BOARD OF ZONING ADJUSTMENT APPLICATION

CMI Engineering, Ltd.

2257 Ashley Drive

Elevated Deck

EXTERIOR Illustration (Location 3)

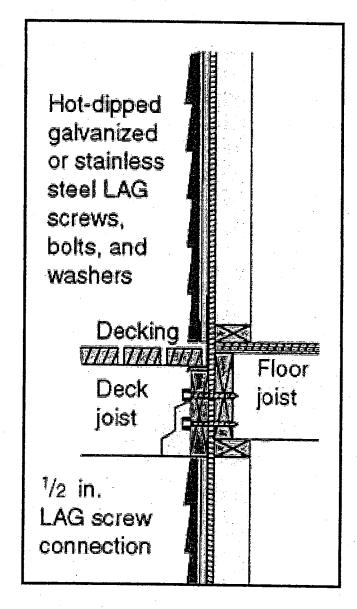
The deck joist are supported by nails in the perimeter joist to prevent rotation; however, they do not provide support.

Engineer's Note: The deck is currently supported by the porch roof.

The deck joist must be supported by hot dipped galvanized or stainless steel joist hangers.

The deck must be attached to the perimeter joist of the structure. The deck ledger, which supports the deck joist, must be attached to the perimeter joist with 1/2" hot dipped galvanized or stainless steel lag bolts, installed at 13" intervals, and staggered top and bottom of the deck ledger. The deck ledger must be the same dimension as the deck joist. The joist hangers and nails must be hot dipped galvanized or stainless steel.
